Maryland Department of Environment
Water and Science Administration
Compliance Program
1800 Washington Blvd, Baltimore, MD 21230
410-537-3510

Site Name: Merritt Properties LLC
Facility Address: 435 Ginn Lane, Pasadena, MD 21122
County: Anne Arundel County

RE: MDE response to comments.

RE: Agency Interest Number: 85638
Tracking: 202060236
Tidal Authorization/Applications Numbers: 20-WL-0141EX/20-WL-0187
Address: 435 Ginn Ln, Pasadena MD 21112

Tidal Wetlands Revetment Placement Review - Permit Map

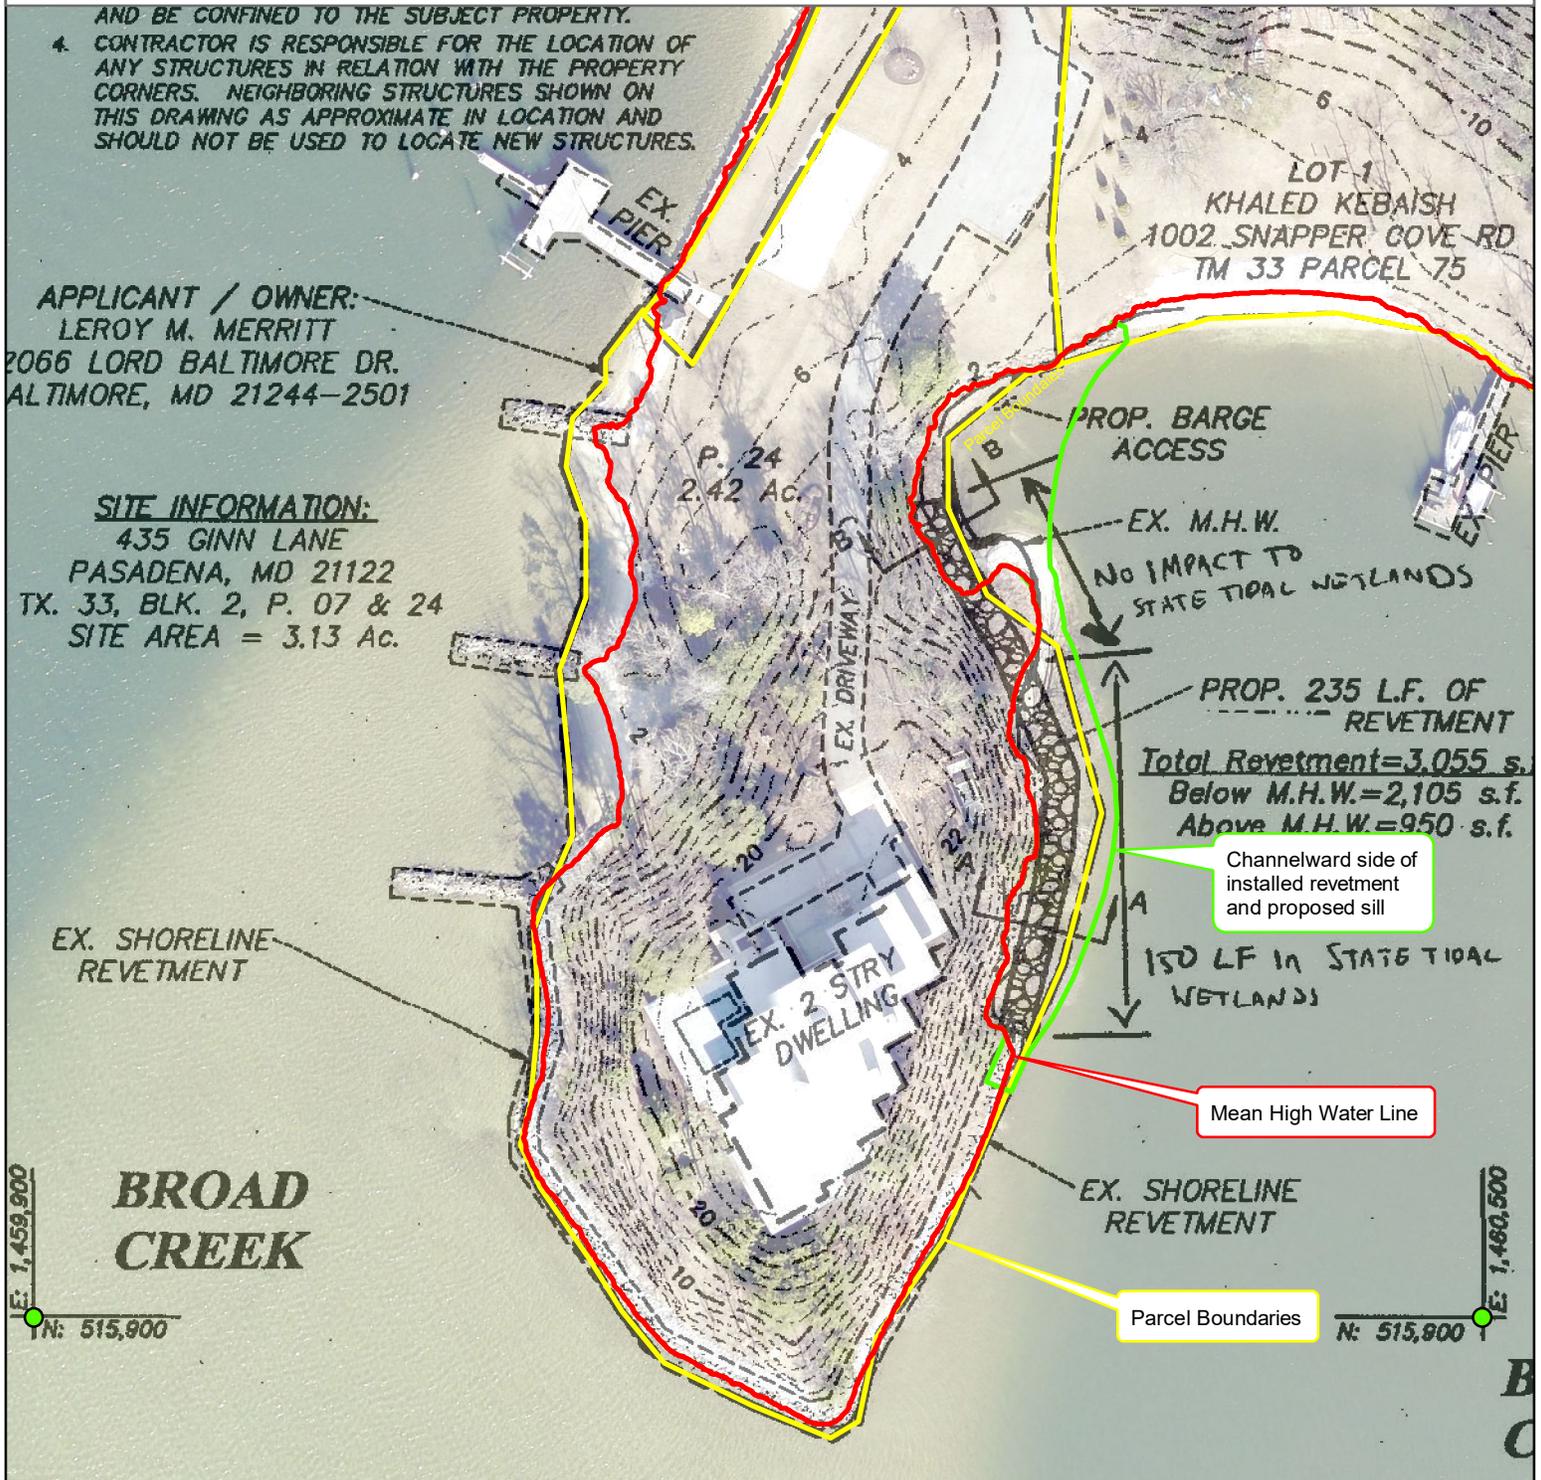
The Maryland Department of the Environment (“Department” or “MDE”) has reviewed comments and documents received from a citizen. Specifically, the citizen was concerned the channelward encroachment extended 40-50’ channelward of the mean high water line (MHWL) and not 21’ as depicted on the site plan. The Department reviewed the provided information in addition to other information. In coordination with MDE’s GIS specialist, the Department determined the following:

- 1) The maximum encroachment of revetment extends 38 feet channelward of the mean high water line.
- 2) An area measuring approximately 150 linear feet by 23 feet wide (fill beyond 10-feet from the MHWL) requires mitigation associated with permanent shallow water impacts. This area (for all fill beyond 10-feet channelward of the mean high water line with a maximum encroachment of 38 feet) is 3,435 square feet (see map: Ginn Ln Results. As discussed previously, an out-of-kind mitigation project requires mitigation at 2:1, thus the Department requires a project resulting in marsh creation to equal 6,870 square feet of planted marsh.
- 3) The proposed mitigation is depicted extending over the extended property line.

- 1) Existing Revetment.
 - a. Due to the provided justification to stabilize the slope and the historic property line (depicted on the attached maps), the Department determined that the plan set for the installed revetment is complete and may proceed with a review, provided mitigation is agreed upon for the loss of shallow water habitat and is included in an application;

- b. As was previously discussed, the Department can authorize the 150 linear feet of revetment that was intended in 20-0141 and an additional 30 linear feet for a total of 180 linear feet north of the previously emplaced revetment.

- c. North of the 180 linear foot mark: based on a combination of the information we have before us and the criteria we must presently use to determine whether a site is eligible for a waiver from the living shoreline requirement, this section does not appear to be eligible for a waiver from the living shoreline requirement, thus the revetment should be removed.

- 2) Mitigation.
- a. Please revise the proposed marsh creation/mitigation so it will not cross the extended property line as depicted on the attached maps.

- b. To help address concerns regarding channelward encroachment, the Department recommends keeping the proposed marsh and stone sill to a maximum of 35 feet channelward of the original mean high water line, which was the proposed encroachment in your resubmittal.
